ADDENDUM NO. 4  
TO THE  
DRAWINGS AND PROJECT MANUAL  
FOR  
**NEW OPPORTUNITY AWARENESS CENTER  
KATY INDEPENDENT SCHOOL DISTRICT  
KATY, TEXAS**

06/17/2026

#### CIVIL CONSULTANT, ADDENDUM No. 4

1 TECHNOLOGY EXISTING OVERALL SITE PLAN  
T1.12 1" = 40'-0"

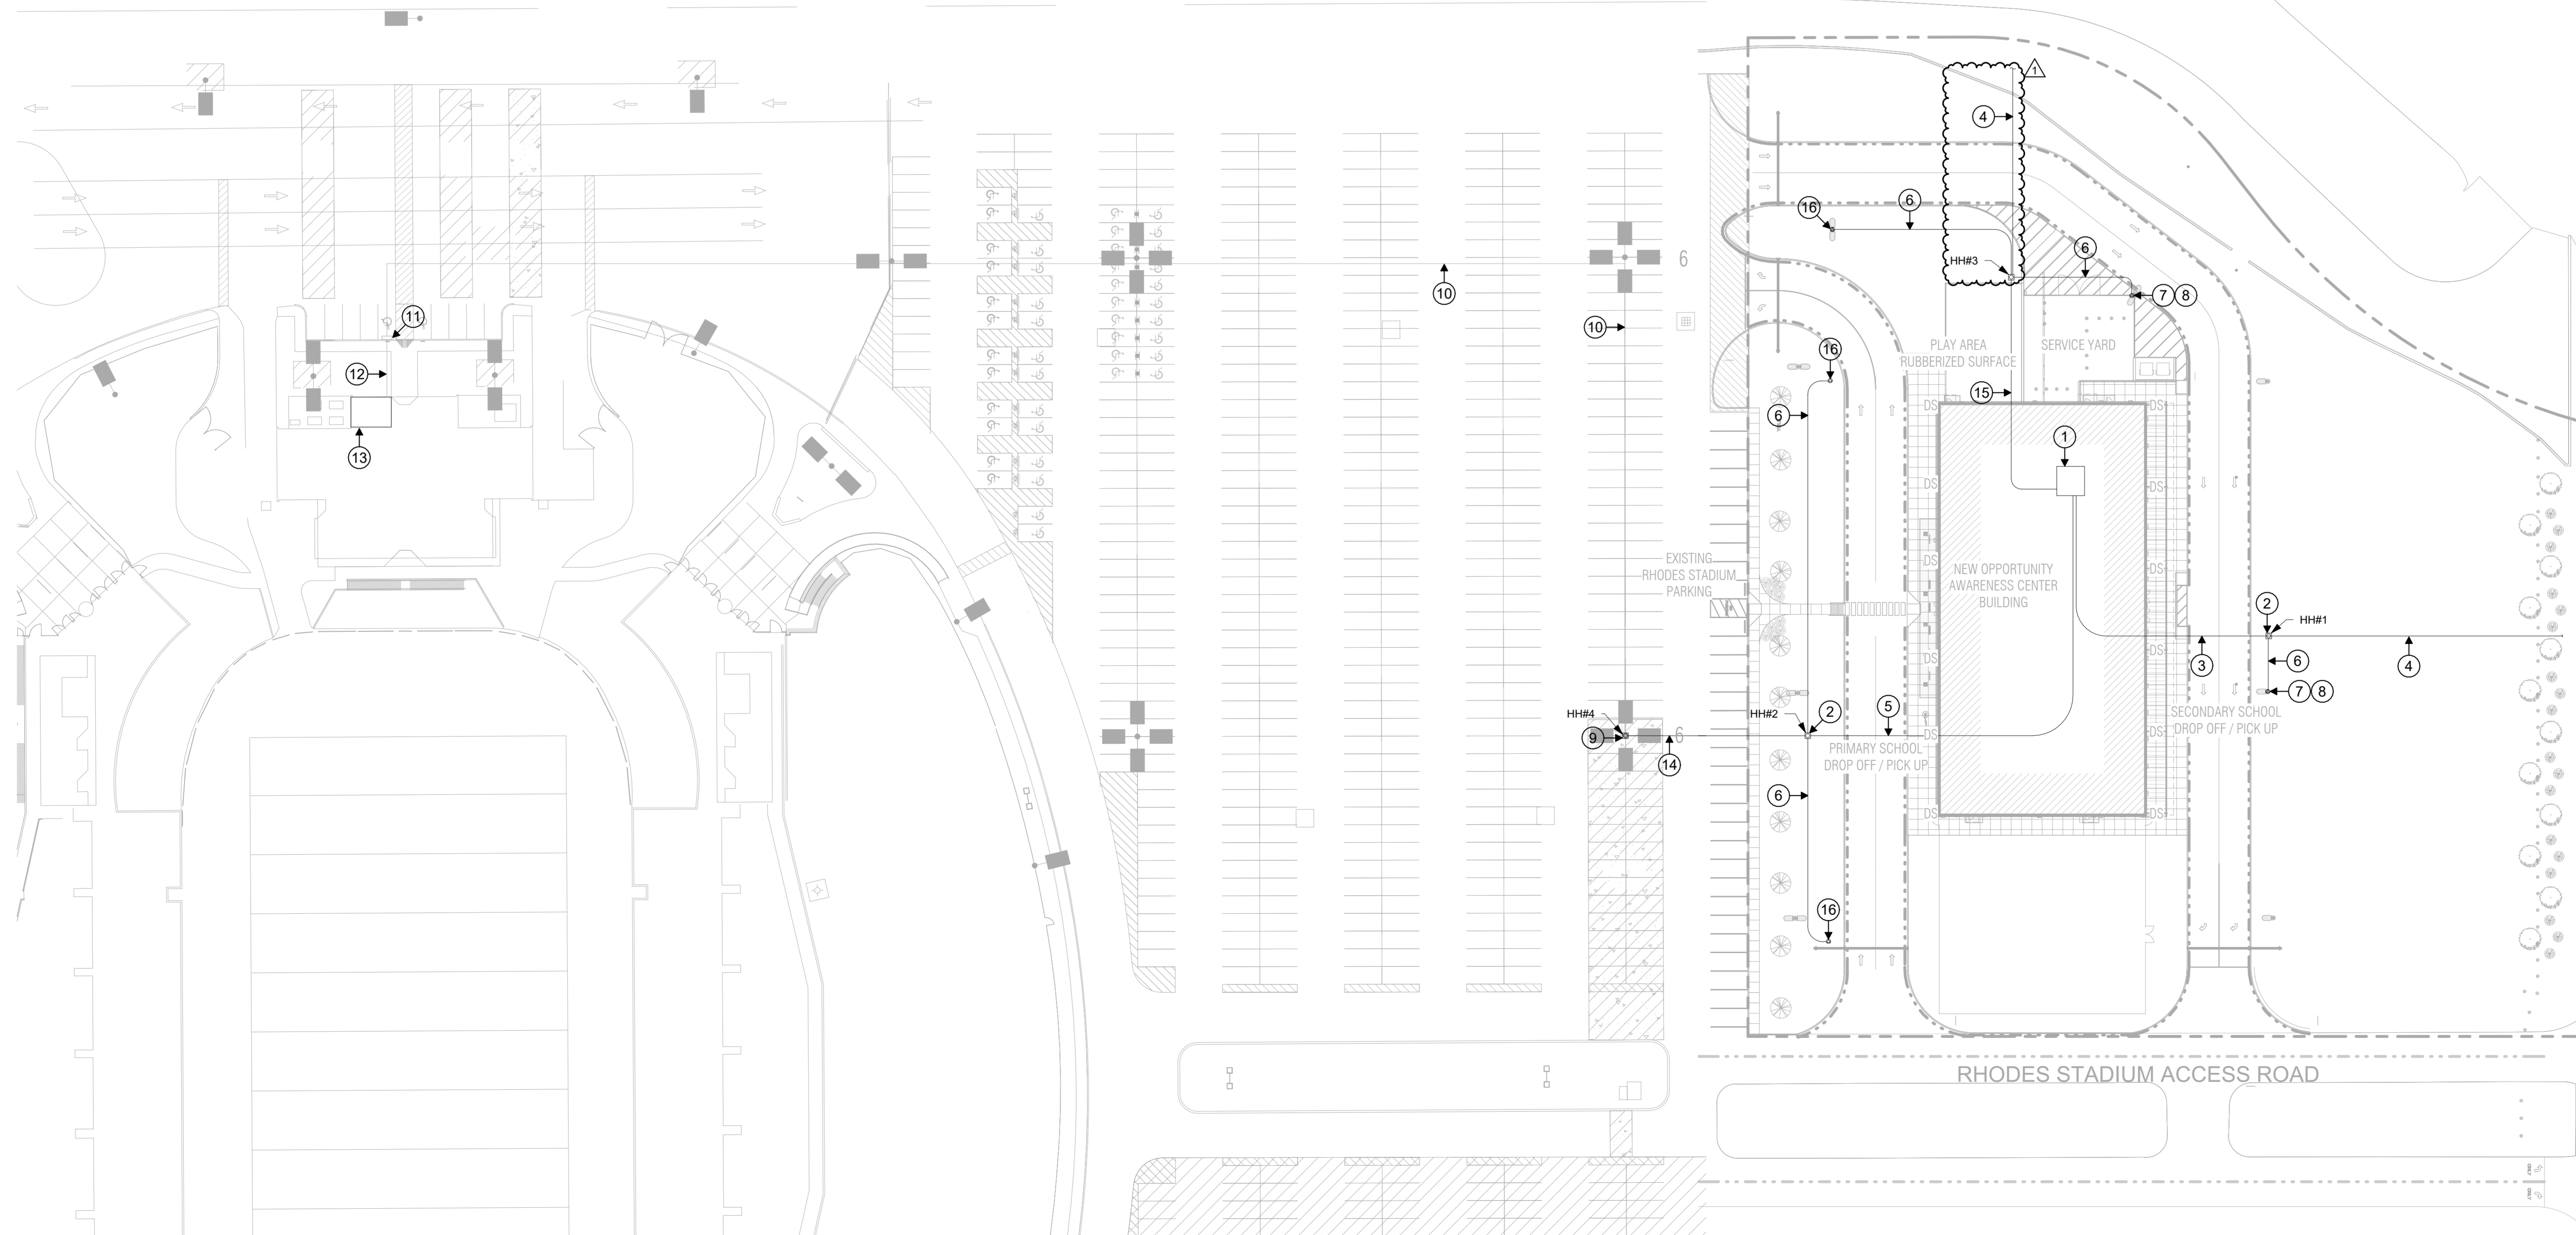
### 3. SHEET T1.12 – TECHNOLOGY EXISTING OVERALL SITE PLAN

- A. Added infrastructure updates to the Technology Overall Site Plan. New pathway routing has been incorporated north of the building to provide a redundant service provider entry point and improve service continuity to the property line.
- B. Revised Keyed Note 15 to increase the pathway requirement from (2) 2-inch conduits to (2) 4-inch conduits to accommodate incoming service provider cabling and provide additional capacity for future expansion.

TPA GENERAL NOTES

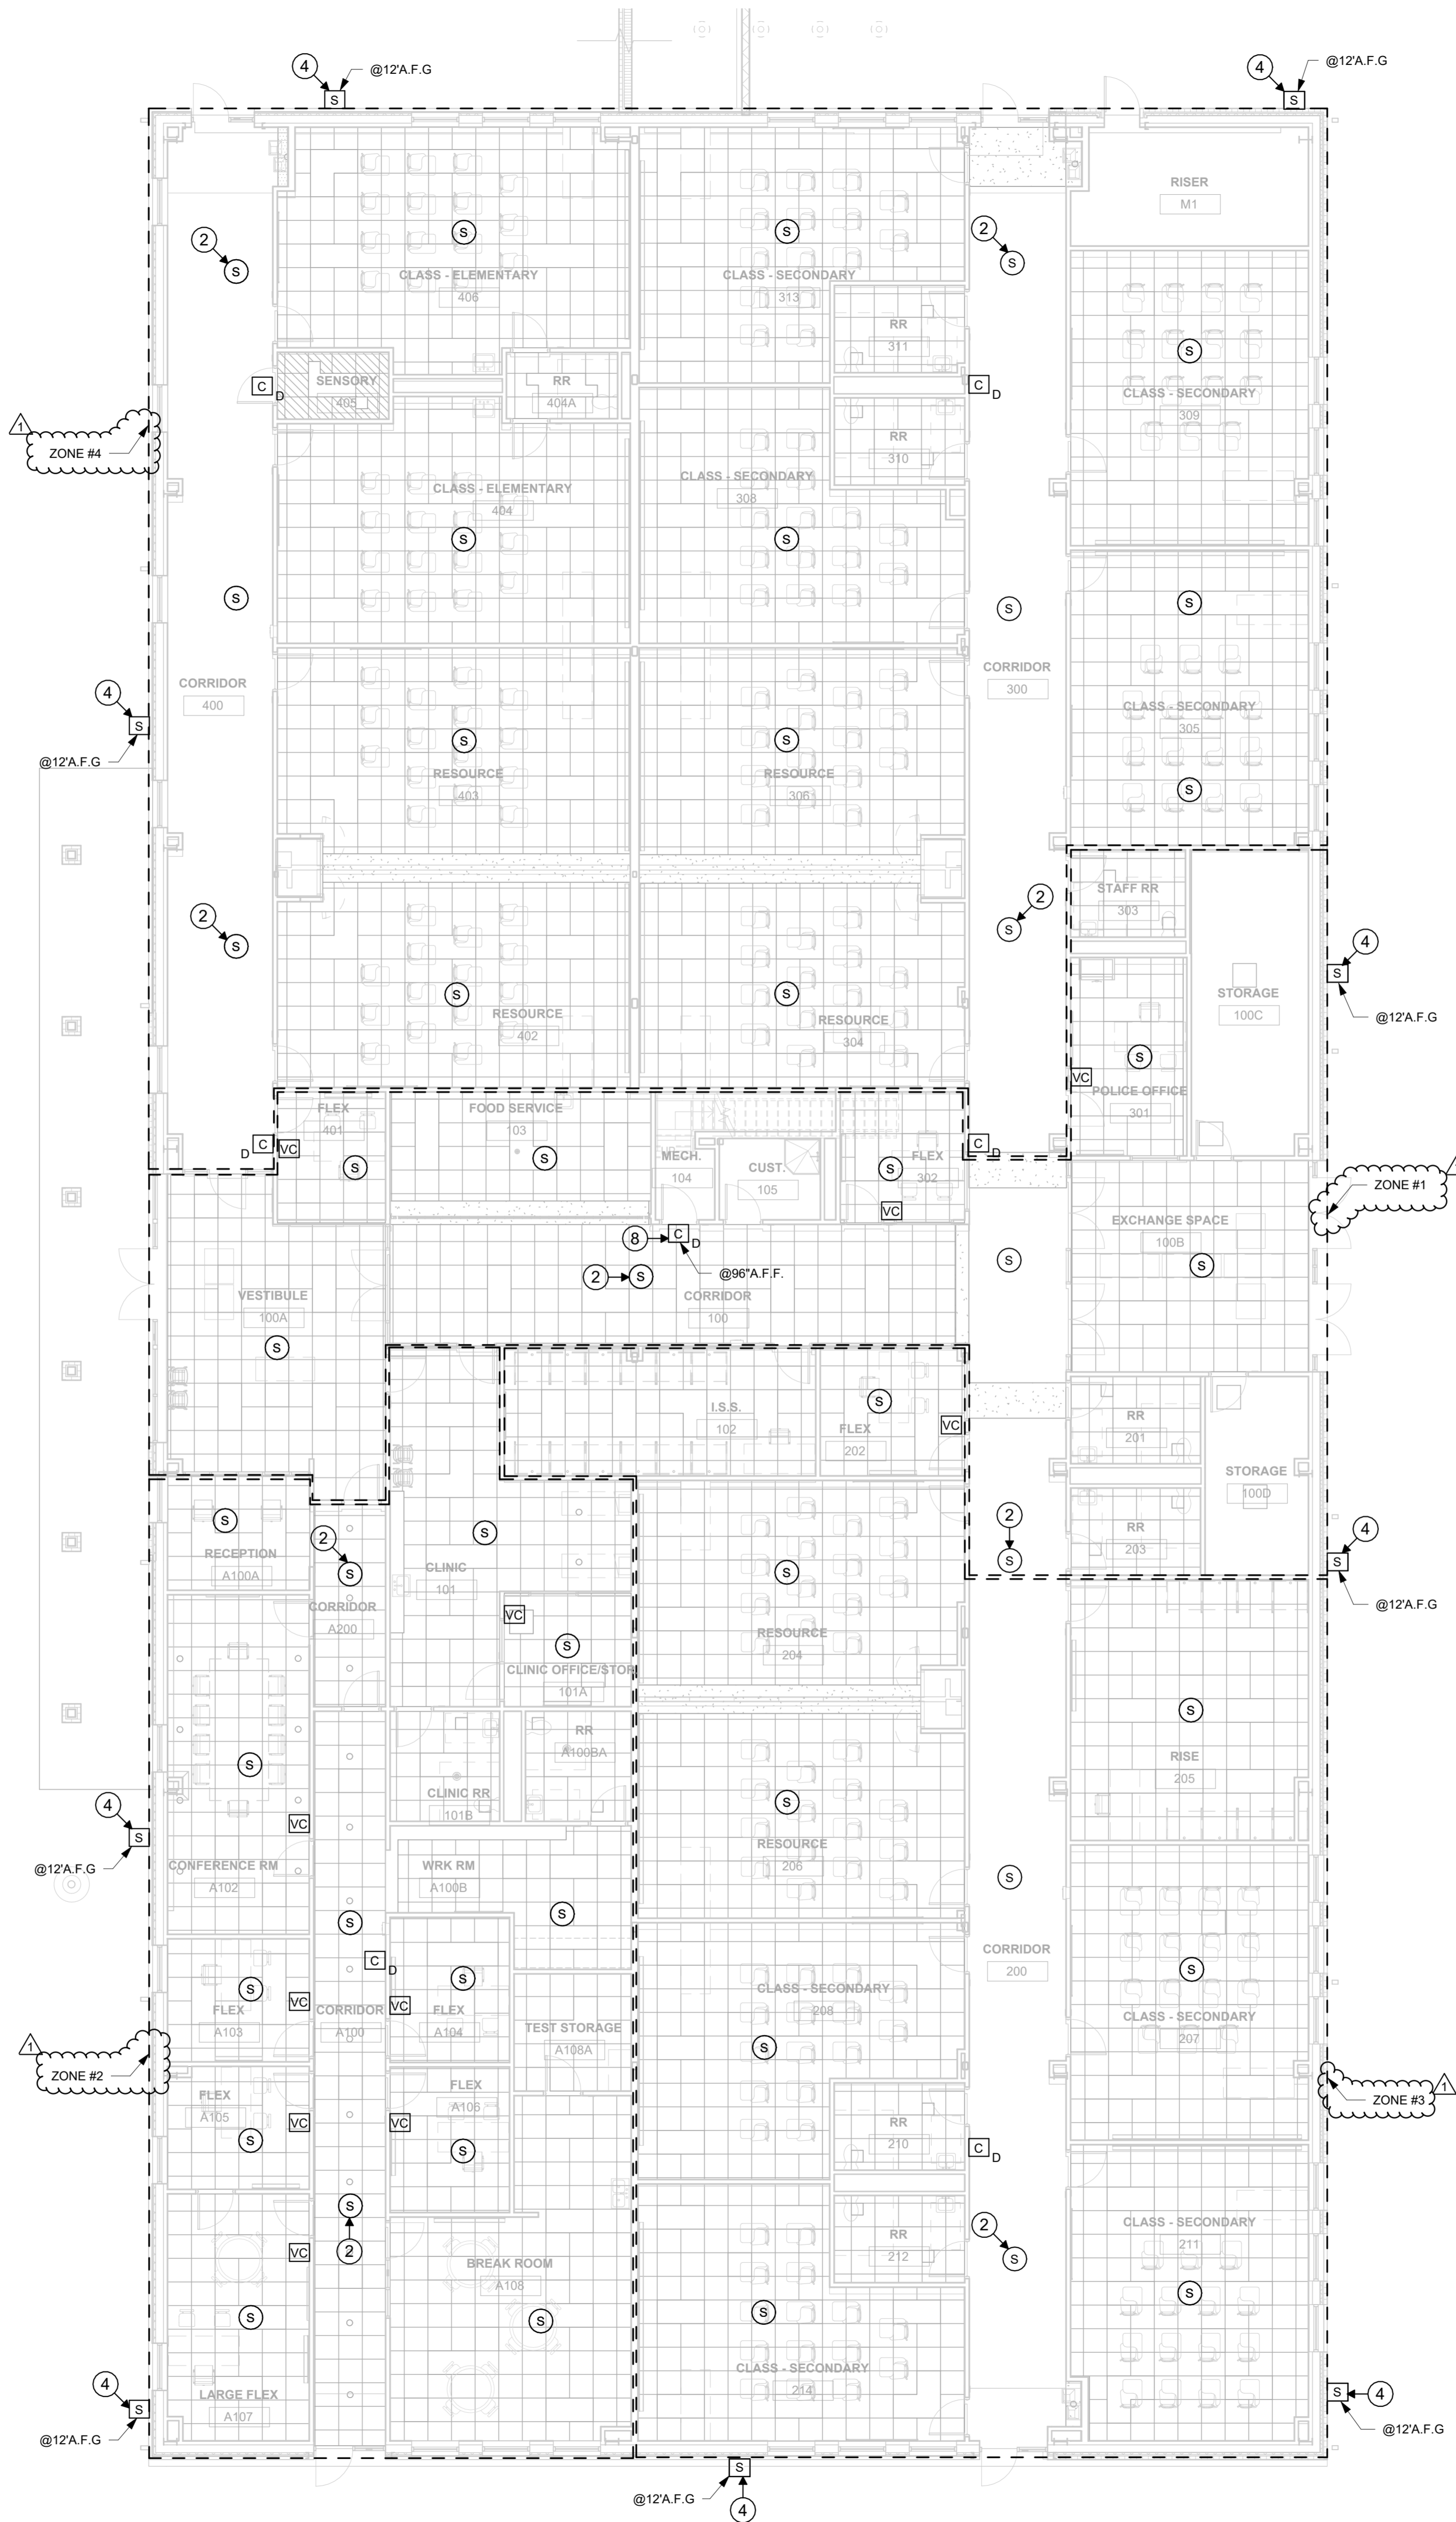
### 4. SHEET TPA2.11 – PUBLIC ADDRESS ORIENTATION PLAN - LEVEL ONE

- A. Revised the paging zone chart to align with district standards and facility operational requirements.
- B. Added paging zone boundary diagrams to graphically identify the extents of each paging zone and clarify area assignments throughout the facility.
